Department of Planning & Development
Office of the Director

DATE: September 8, 2006
TO: Capitol Gateway Corridor BUILD Committee
FROM: Mark A. Olinger, Director
Department of Planning & Development
SUBJECT: Capitol Gateway Corridor BUILD Memo

#1

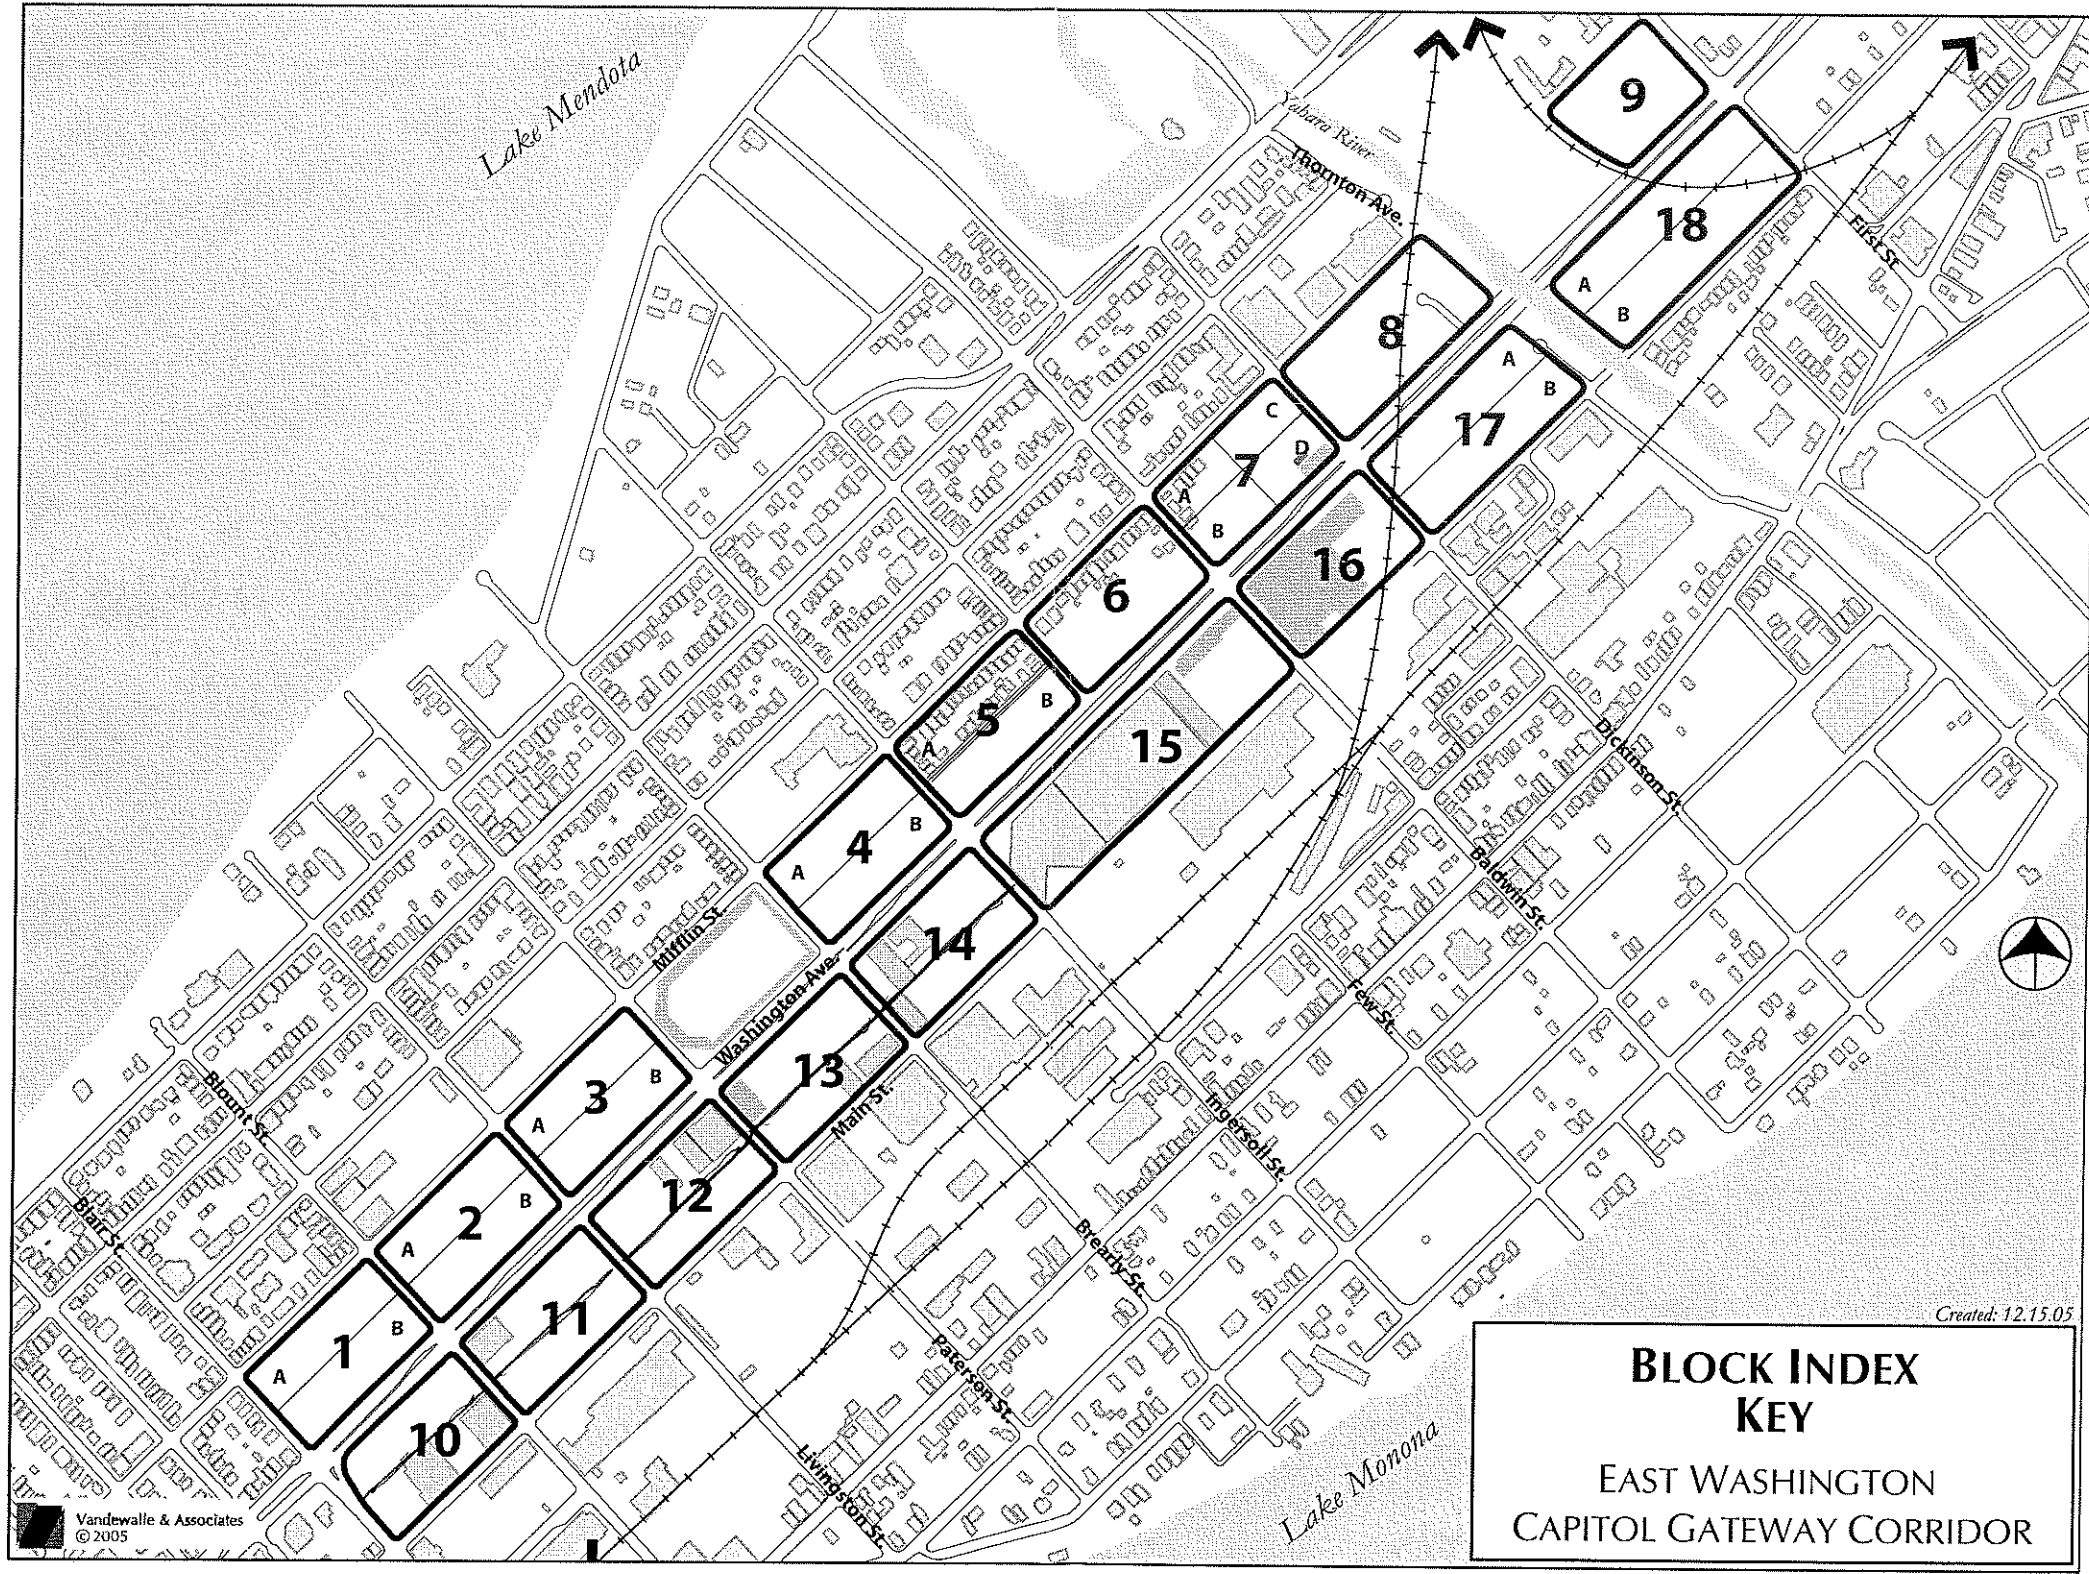
In order to fully address this issue, Department staff has suggested two changes in Blocks 8 and 17 (Please see Page 2, Attachment #1). We have added sub-blocks 8.a. and 8.b. In addition, the boundary between 8.a. and 8.b. run perpendicular to East Washington Avenue unlike almost all other blocks, which are parallel to East Washington. The same happens in Block 17, but we have added a third sub-block, 17.c. Block 17.a. and 17.b. both have Yahara River frontage, 17.c. does not.

BLOCK 8
 DIVIDED
 INTO 2 BLOCKS

BLOCK 17
 DIVIDED INTO
 3 BLOCKS

Figure A: 15 Story Tower

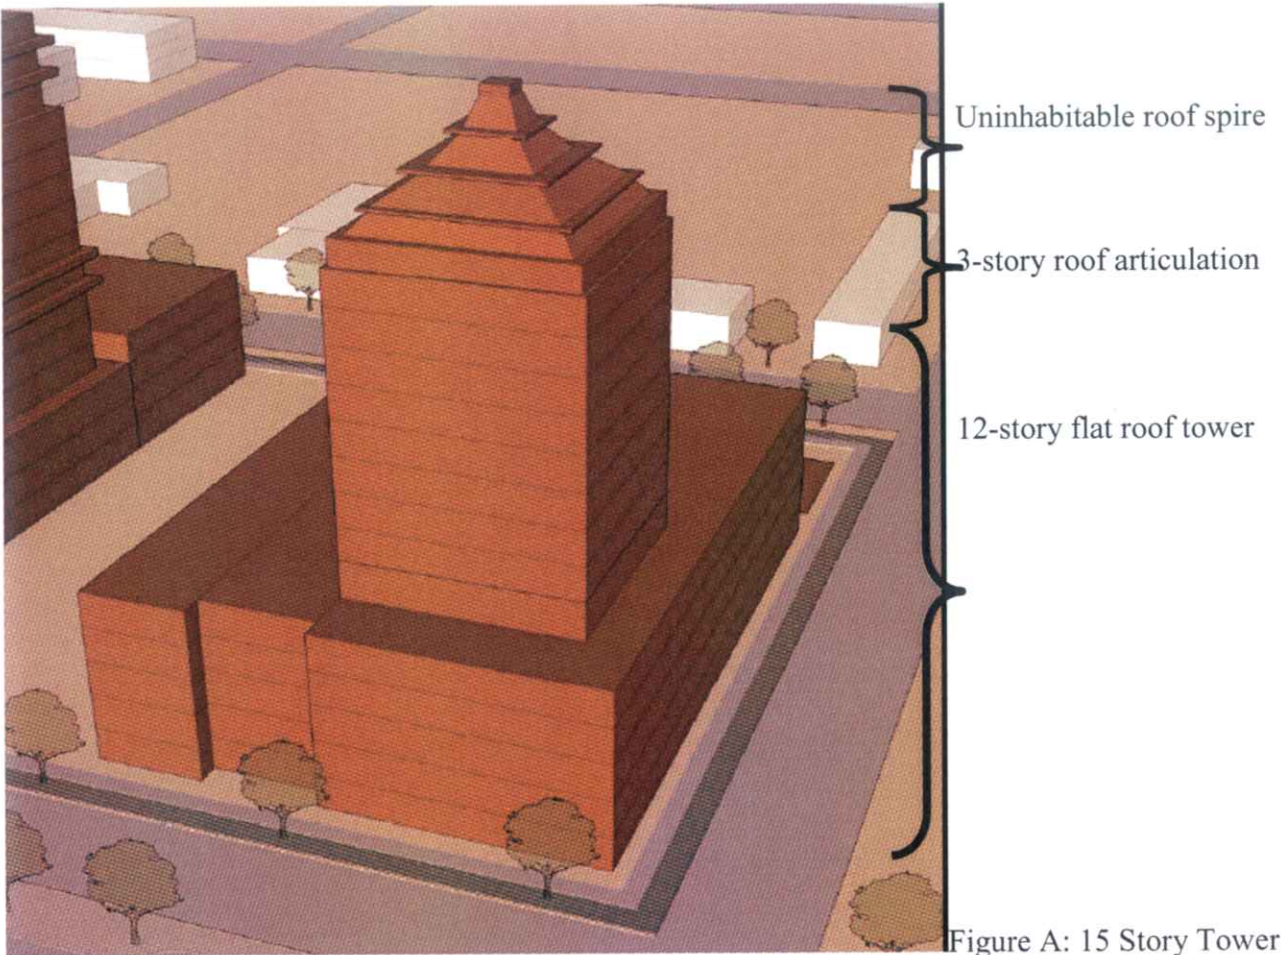
- Buildings that have uniquely shaped roof treatments and upper story articulation may be built to the full maximum height of 15 stories. (See figure B)

Figure B: 12 Story Tower

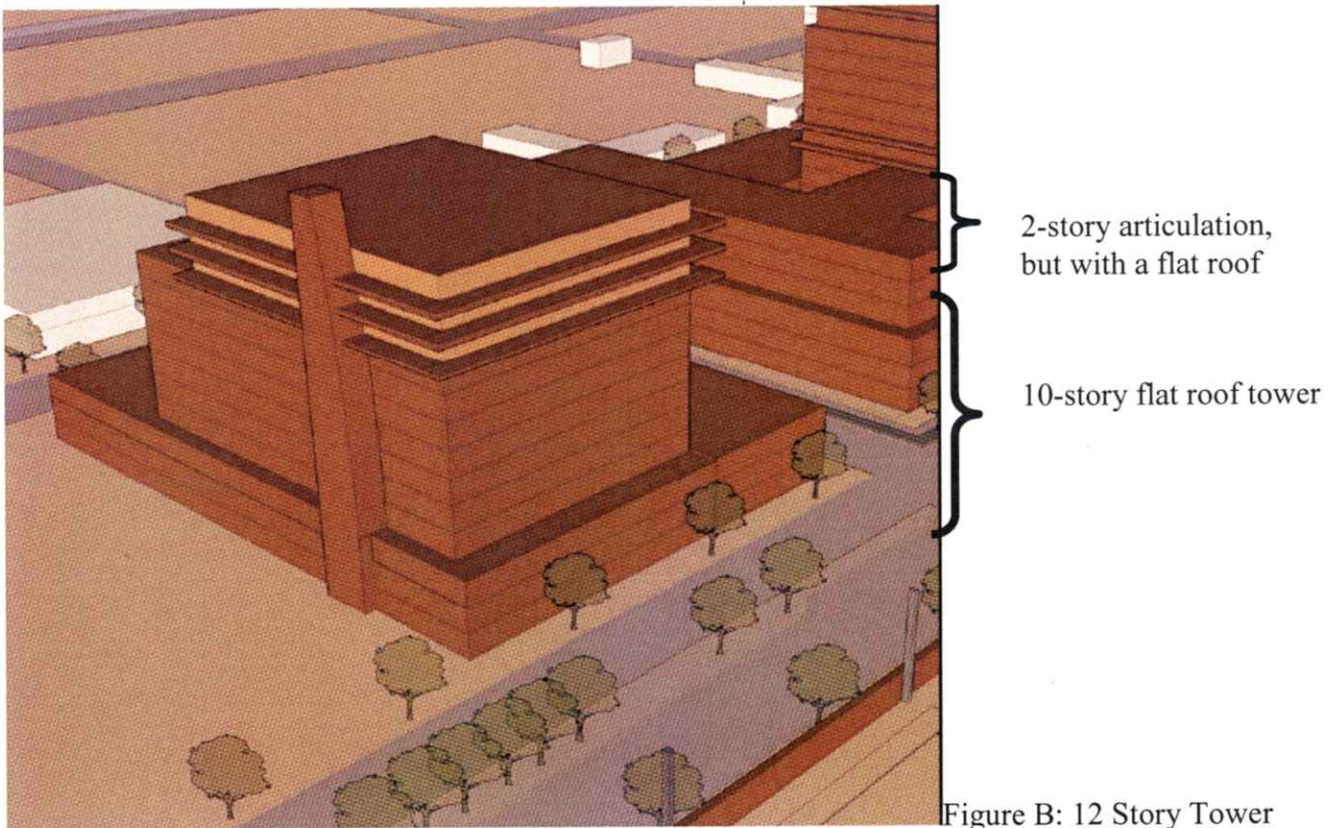
- Buildings that have uniquely shaped roof treatments and upper story articulation may be built to the full maximum height of 12 stories. (See figure A)

Figure C: 45 degree setback limits above 5 stories. Upper Story articulation and roof treatment may or may not meet roof articulation standards. Additional language will have to clarify this point.

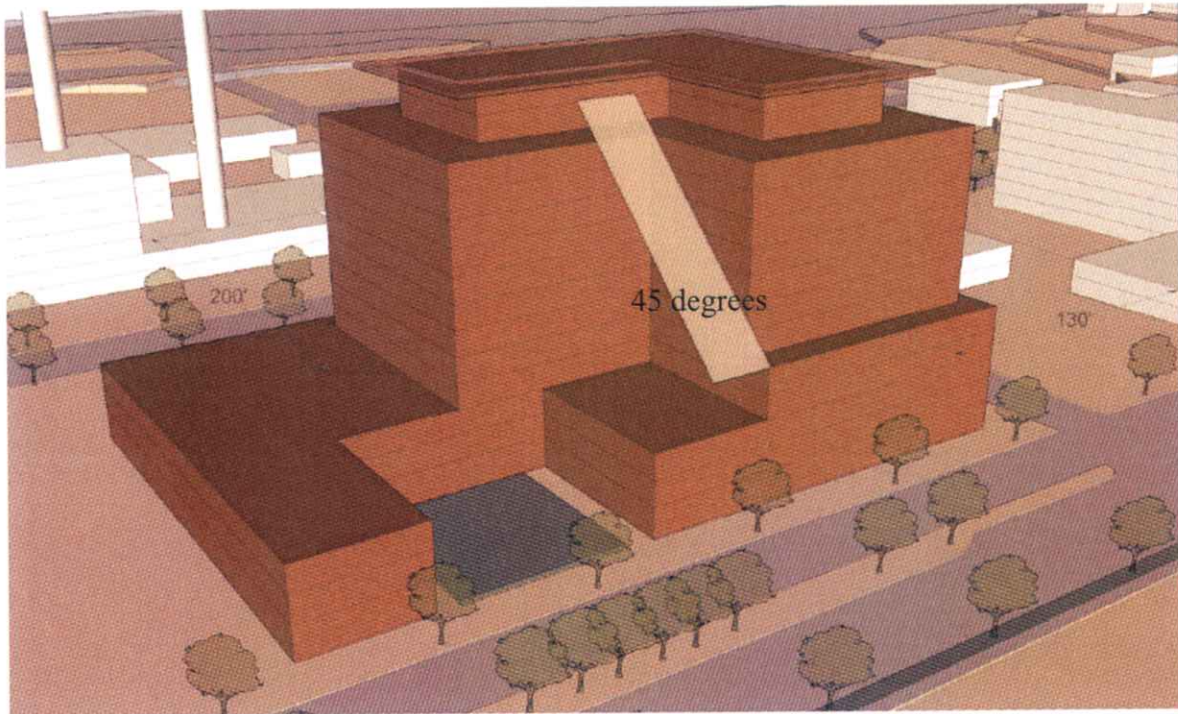
- If construction methods and/or site characteristics deem it necessary, this envelope may be exceeded by 10%.
 - Any other building mass above 5 stories, not confined within the tower envelope must follow a 45% stepback. (see figure C)
